EARLY DESIGN GUIDANCE #2

1100 BOYLSTON | SEATTLE, WA 98104

MAY 15, 2019 | SDCI #3033262-EG

MASSING EXPLORATIONS

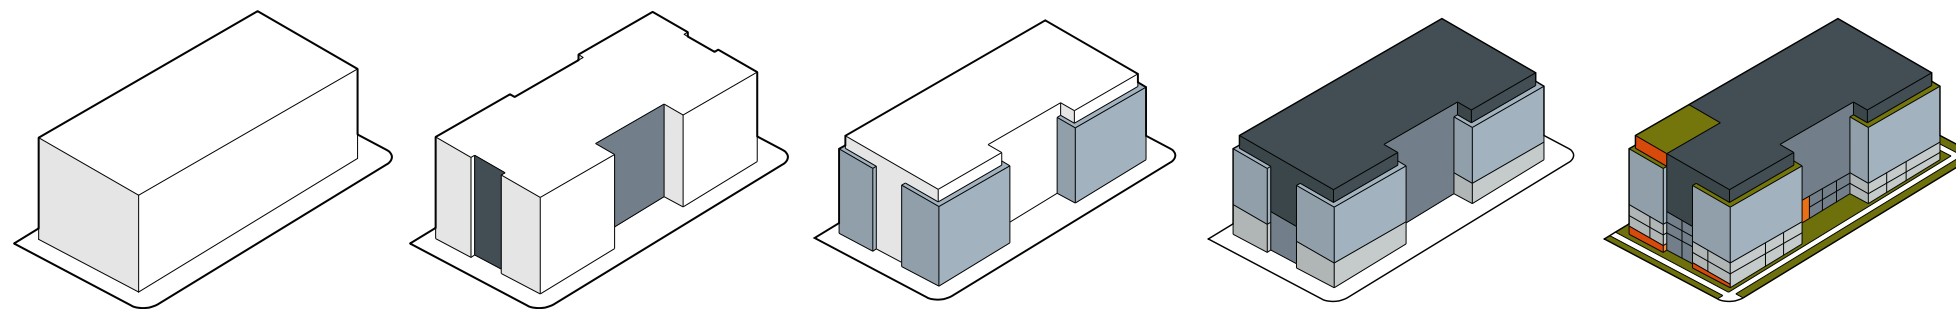
The Board was disappointed by the lack of any significant variation between the three schemes, and that there was no exploration of other forms that might allow the project to step back from the street-edge and create conditions that better meet the criteria in the Design Guidelines. (CS2-D, DC2-A, CS2-C)

Response: Additional massing forms have been studied - see opposite page. The revised preferred massing scheme includes a significant step back on Boylston as requested by the Board (DC2-A-1, CS2-C-3).

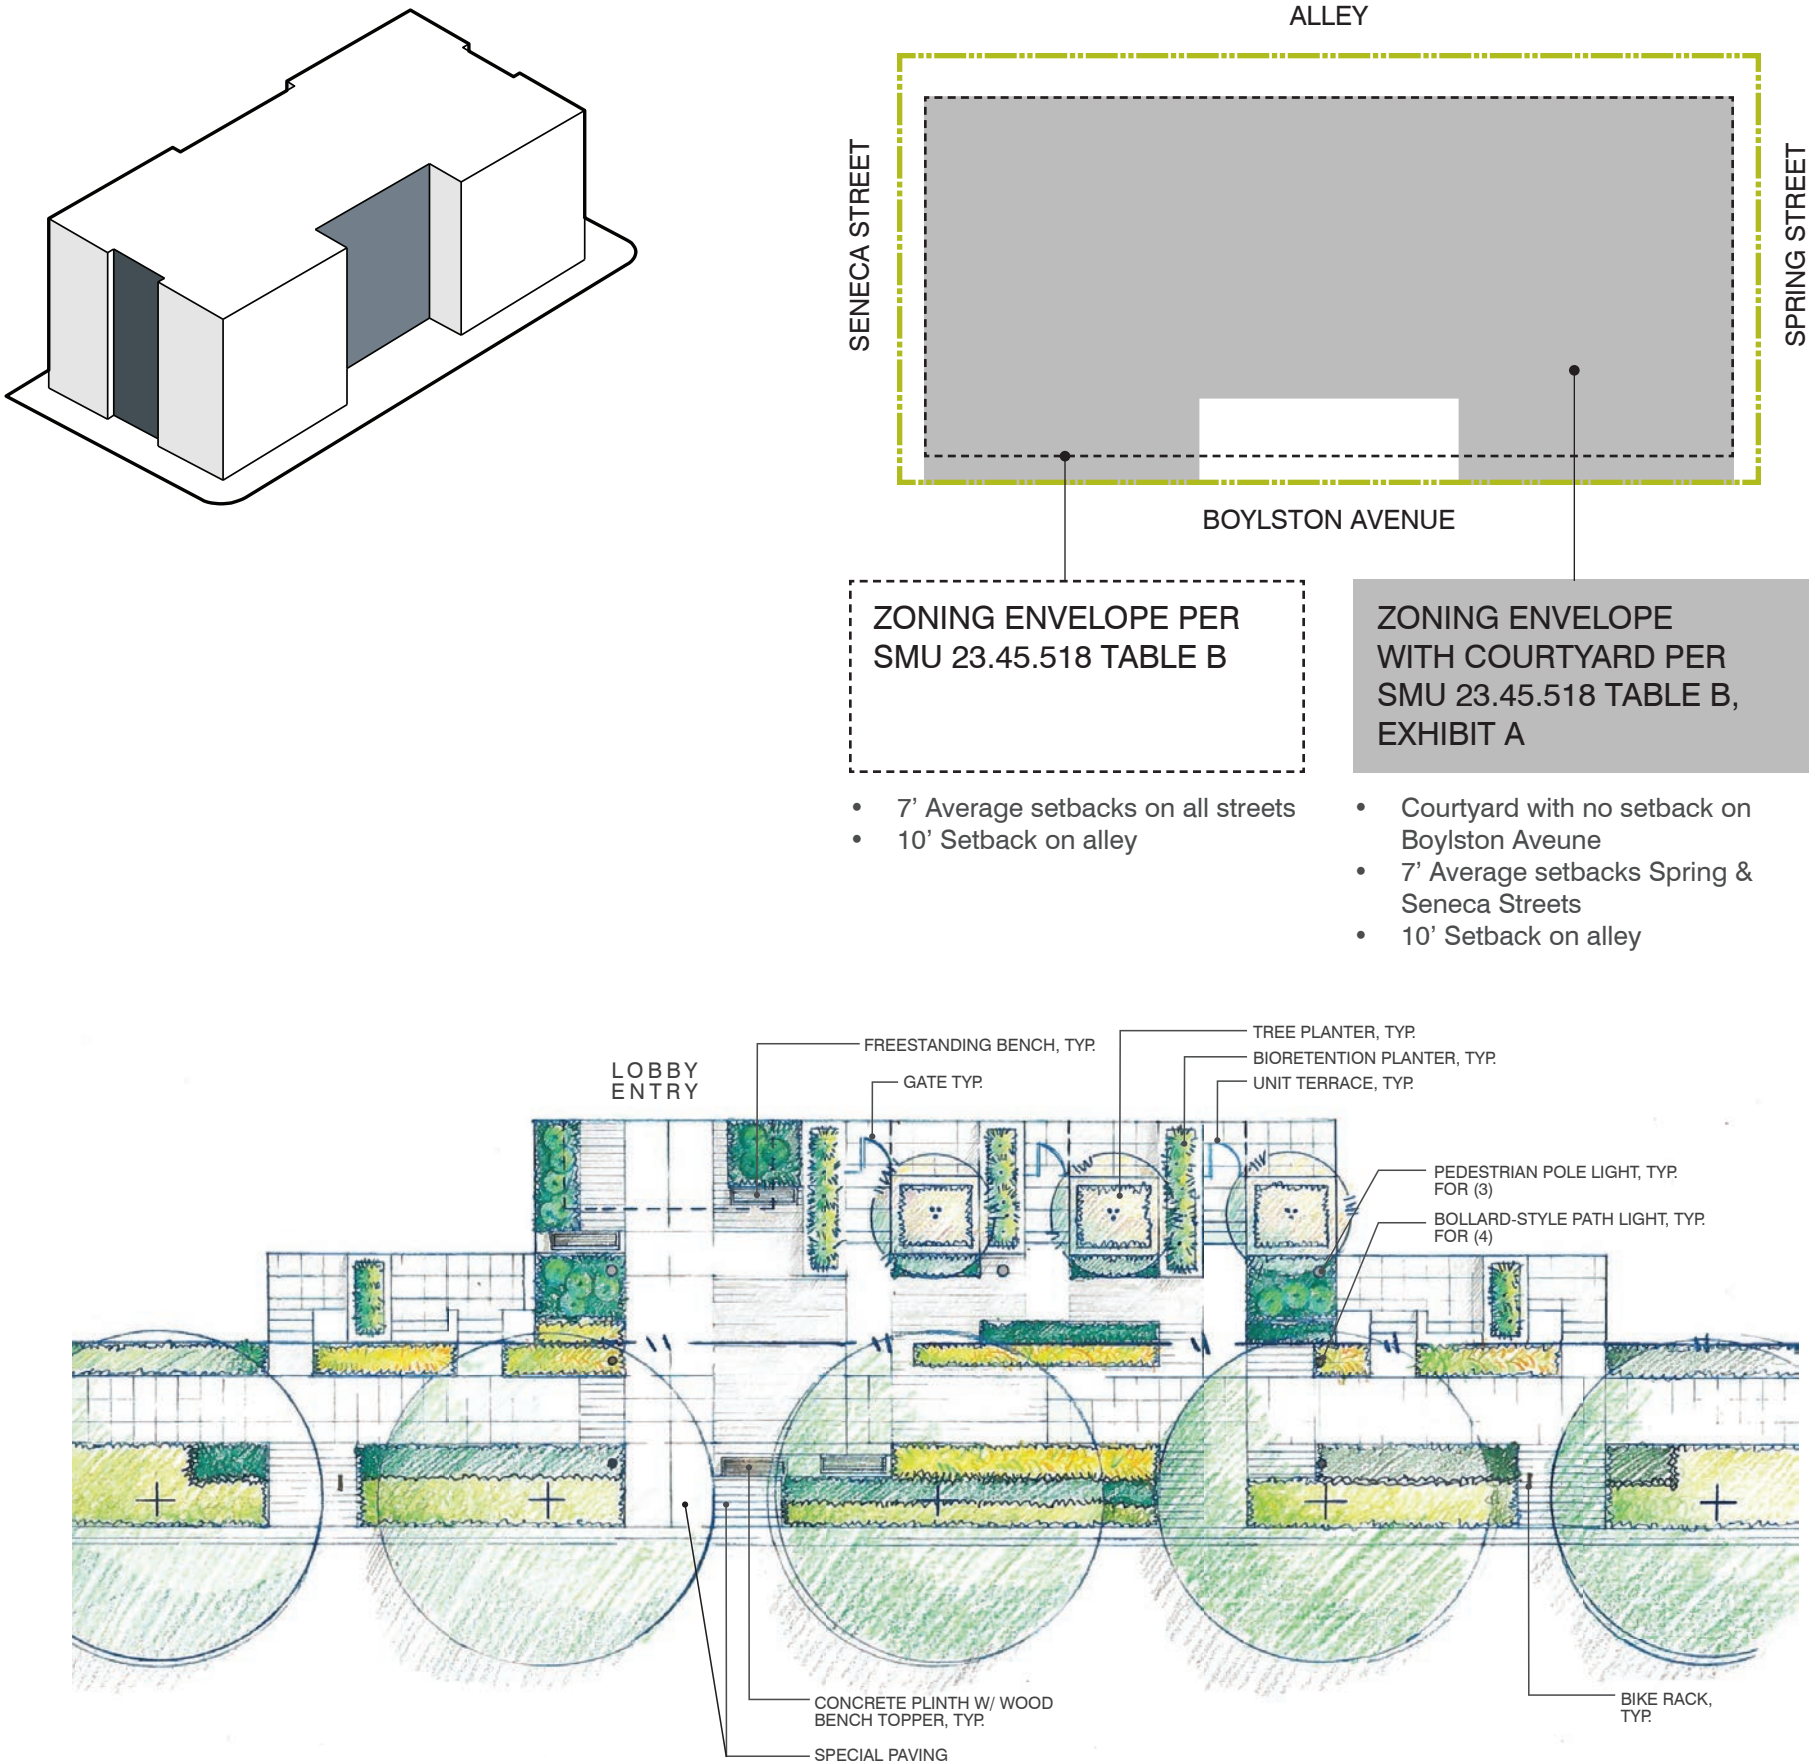
b. The Board supported the applicant’s intent to mitigate the project’s height, bulk and scale. The proposed 8-story height is significantly lower than the permitting zoning height and the height of nearby residential towers, but the Board agreed that the shallow massing moves shown in all three schemes were inadequate to mitigate the bulk and scale. (DC2-A, DC2-B)

Response: The massing has been revised to create a much more significant vertical break in the building massing, with a step back of 20 feet in lieu of the 6 foot step back in the previous scheme. This breaks up the long façade along Boylston Avenue.
- c. The Board agreed that the unrelieved eight-story massing along the full block did not meet Design Guidelines around bulk and scale and asked the applicant to explore revisions to massing including courtyards, other ground-level setbacks, significant modulation, and upper-level setbacks (possibly augmented with a change in materials). (CS2-A, CS2-B, CS3-A, DC3-B)

AMENITY ADJACENT TO LOBBY

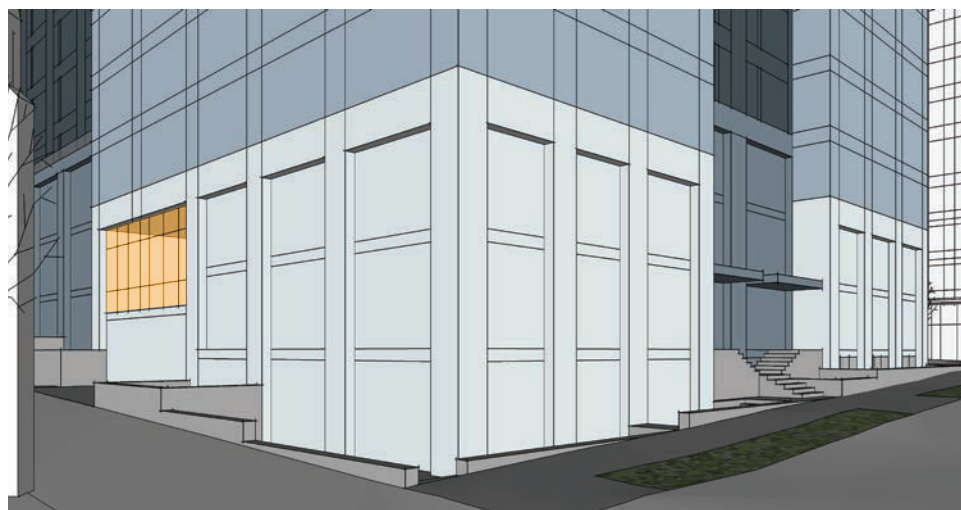
- g. The Board agreed that relocating the amenity space to be adjacent to the entry could provide the opportunity to create a visual connection from street to alley that would clearly identify the entry, mitigate the scale of the project as experienced from Boylston, and provide activation and safety at the alley adjacent to the church. (DC1-A, PL2-B)

Response: Locating the fitness amenity space adjacent to the new lobby location was explored, but the design team felt the location at the lower level worked better because 1) it provides a better acoustic separation between the amenity space and the units; 2) the potential visual connection to the alley is less appealing towards the center of the alley (adjacent to the lobby), where there is a blank wall at the church - than towards the north end of the alley (the preferred amenity location) (DC1-A-4); and 3), locating the amenity towards the center requires units to be located at the below-grade condition at the north end, which is not desirable (PL3-A-3).

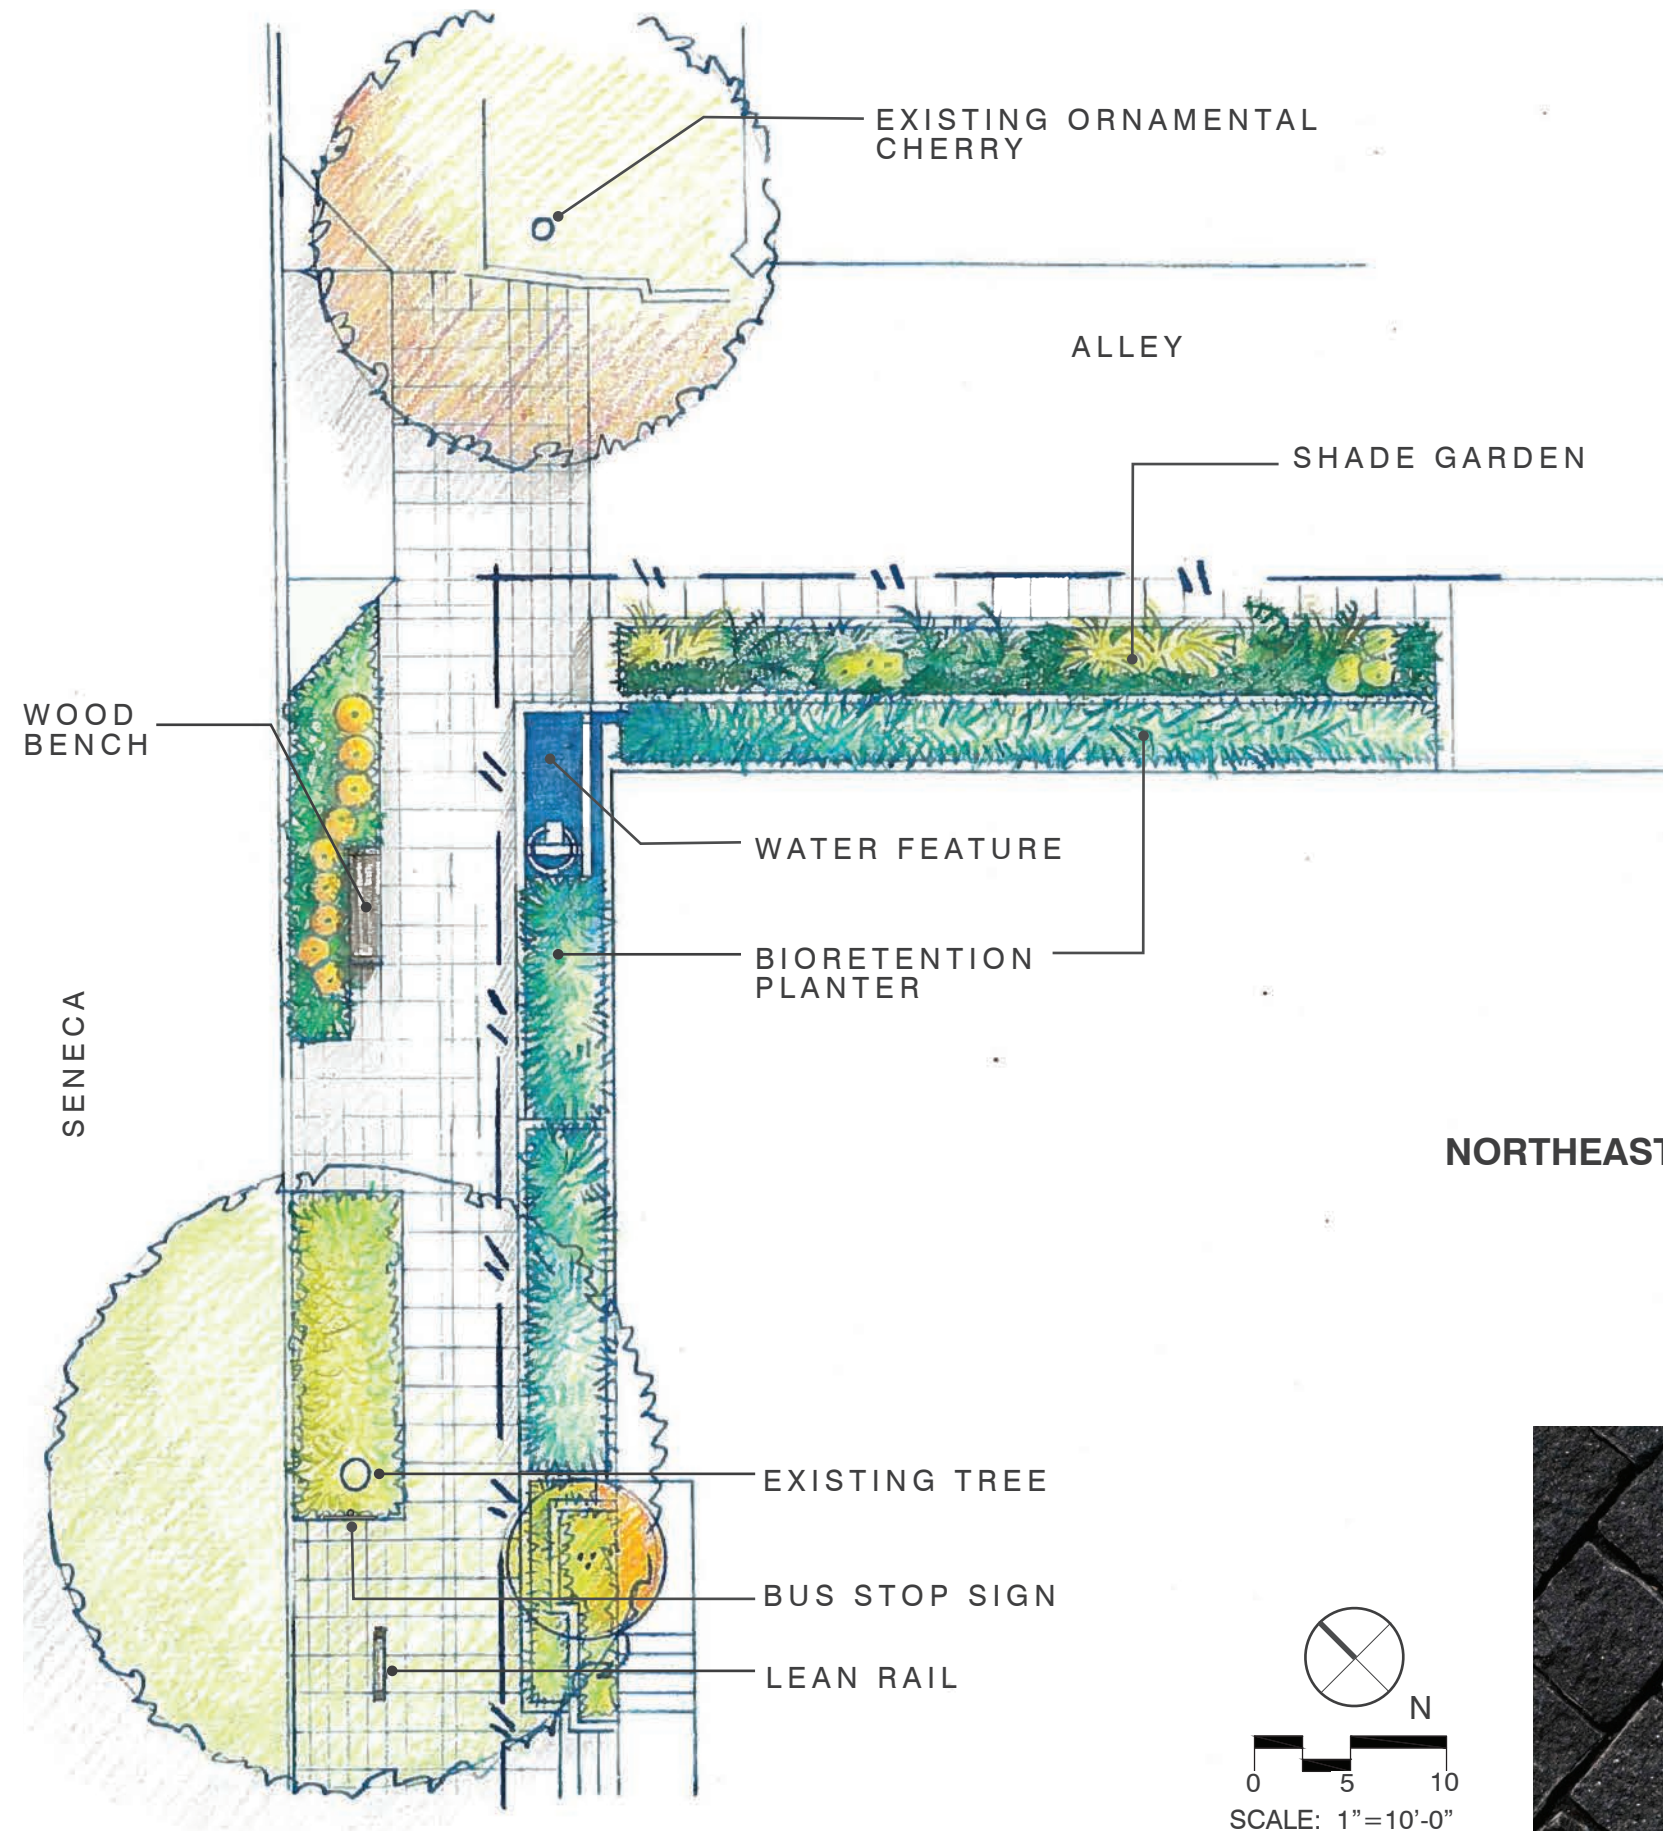
- h. The Board wondered how Green Factor criterion would be met and suggested that those elements (such as trees, storm-water infrastructure, planting beds) could be incorporated into the design of open space at ground level. (DC4-A, DC4-D)

Response: The landscape design has been modified to incorporate the entry courtyard and clarify the use of bio-retention planters at the street level (DC4-D-1, DC4-D-4).

SOLID WASTE STAGING DIAGRAM

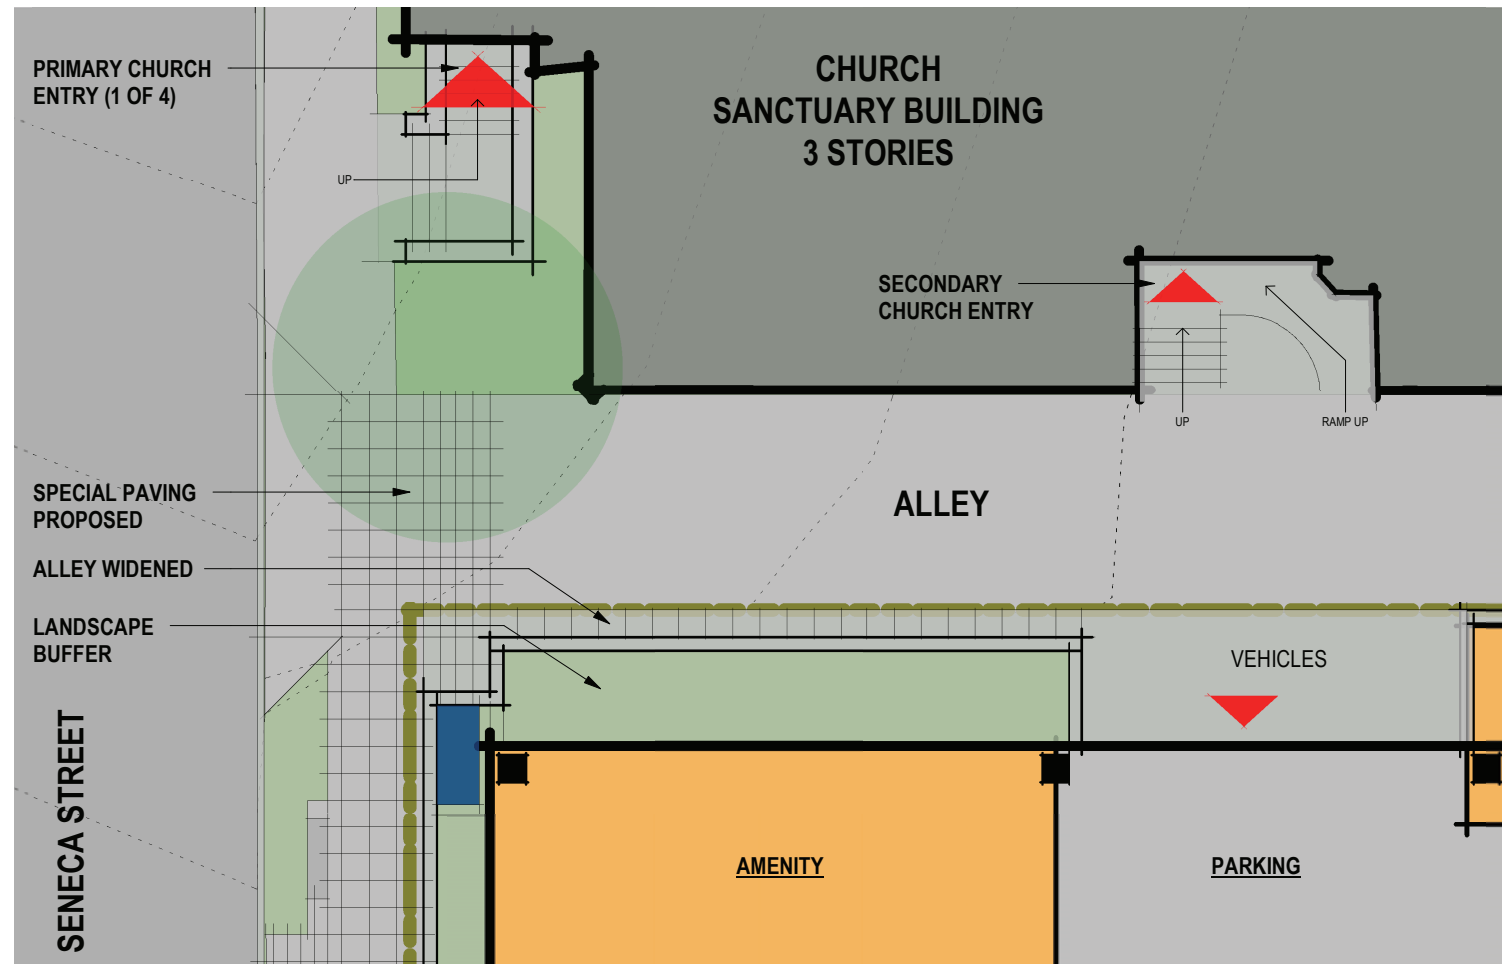
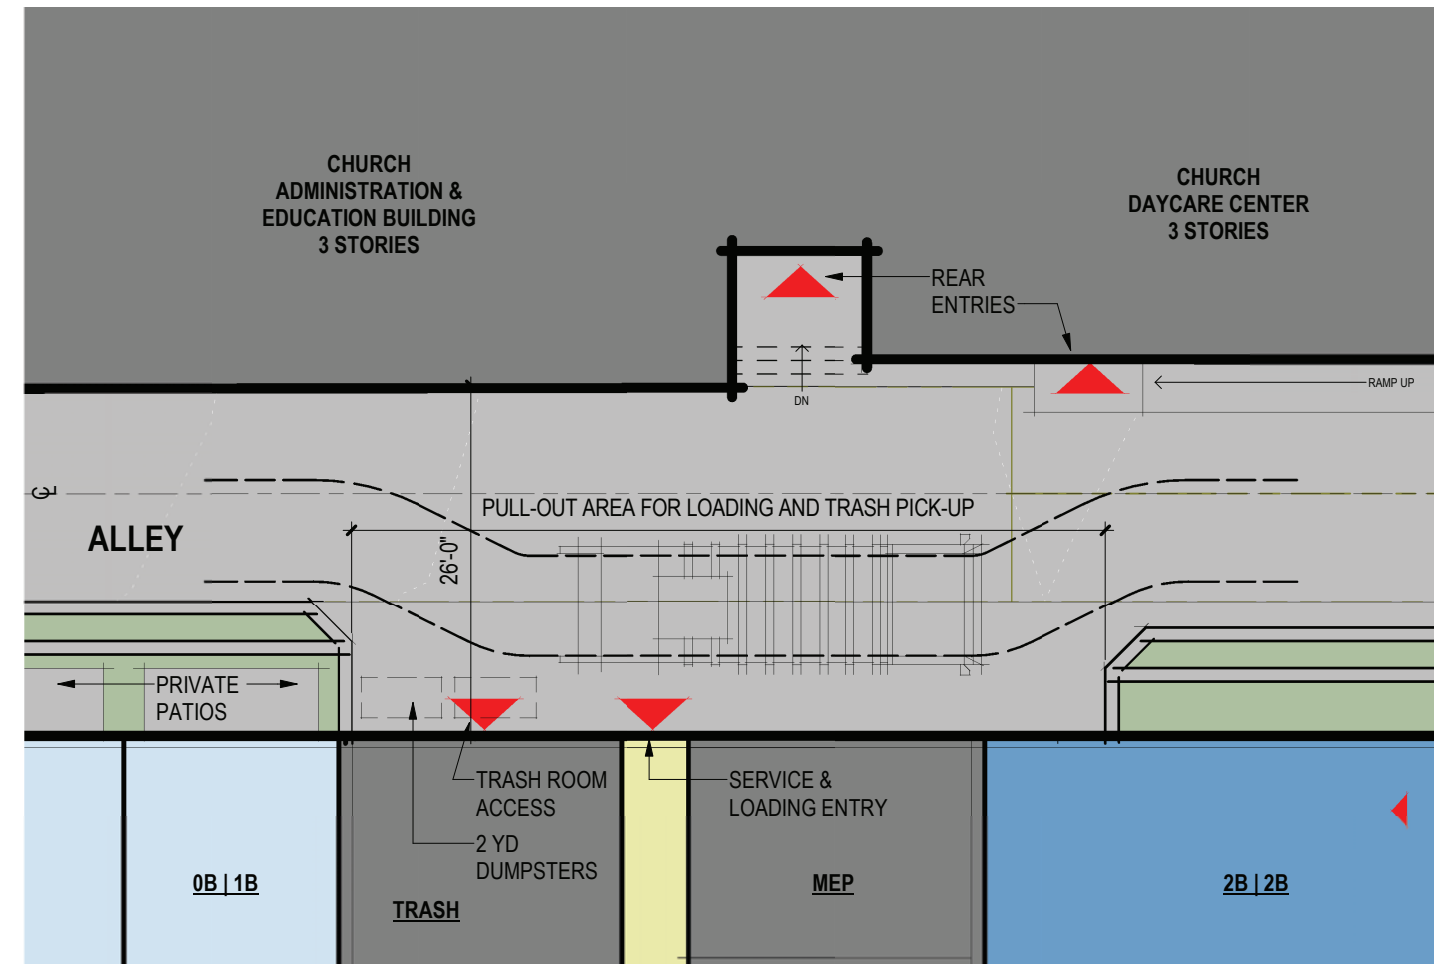
The Board agreed that the treatment of the alley was an important aspect of the design and asked that it be developed as a safe and understandable route for vehicles and pedestrians, and that waste management be collected and staged onsite.(PL2-B, DC1-A, DC1-B)

Response: The alley at the north end has been widened to improve visibility at the vehicle entry (DC1-A-1) and provide additional space for vehicles and pedestrians near the sidewalk on Seneca. A vehicle pull-out has been provided adjacent to the trash room off the alley, allowing trash pick-up to occur on-site (DC1-B-1). Additionally, units are located facing the alley, with raised private outdoor spaces to provide “eyes on the street” (PL2-B-1), with a landscape buffer to provide separation and a better pedestrian experience at the alley.
